**COMMITTEE OF THE WHOLE JUNE 18, 2007**

**ZONING BY-LAW AMENDMENT FILE Z.06.045  
DRAFT PLAN OF SUBDIVISION FILE 19T-06V07  
BELMONT PROPERTIES  
REPORT # P.2006.55**

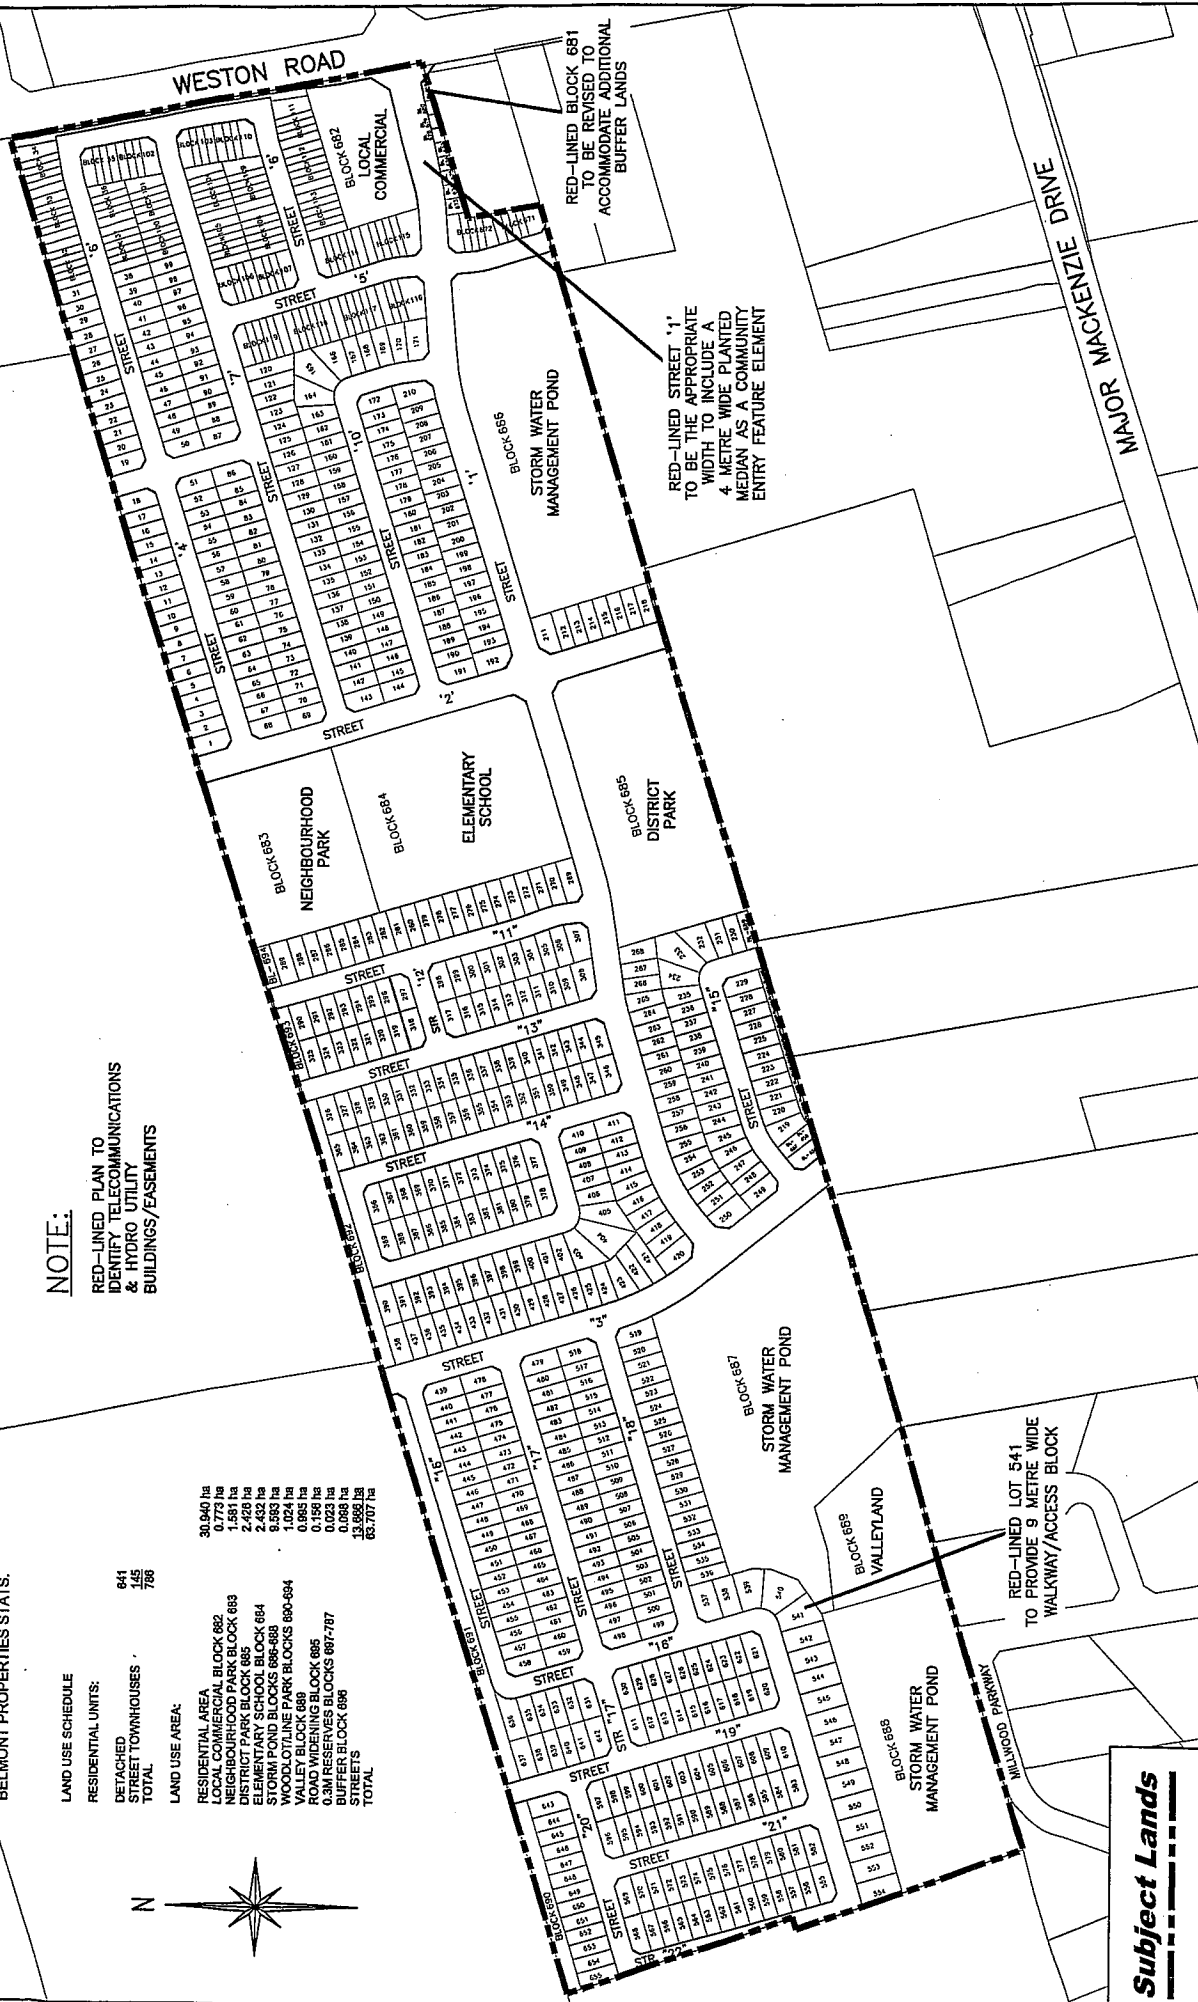
The Development Planning Department has reviewed the proposal and requires the following red-lined revisions to the proposed draft plan of subdivision, as shown on Attachment #3:

- i) Lot 541 has been red-lined to provide for a 9 m wide pedestrian/access road block which shall provide access to the stormwater management pond facilities;
- ii) Street "1", where it intersects with Weston Road, shall be of an appropriate width to include a 4 m wide landscape median as a community entry feature element;
- iii) Block 681 shall be revised to accommodate additional lands for the buffer; and,
- iv) the telecommunication and hydro utility buildings/easements shall be identified on the draft plan;

RED-LINED PLAN TO IDENTIFY TELECOMMUNICATIONS & HYDRO UTILITY BUILDINGS/EASEMENTS

RED-LINED STREET '1' TO BE THE APPROPRIATE WIDTH TO INCLUDE A 4 METRE WIDE PLANTED MEDIAN AS A COMMUNITY ENTRY FEATURE ELEMENT

RED-LINED BLOCK 681 TO BE REVISED TO ACCOMMODATE ADDITIONAL BUFFER LANDS
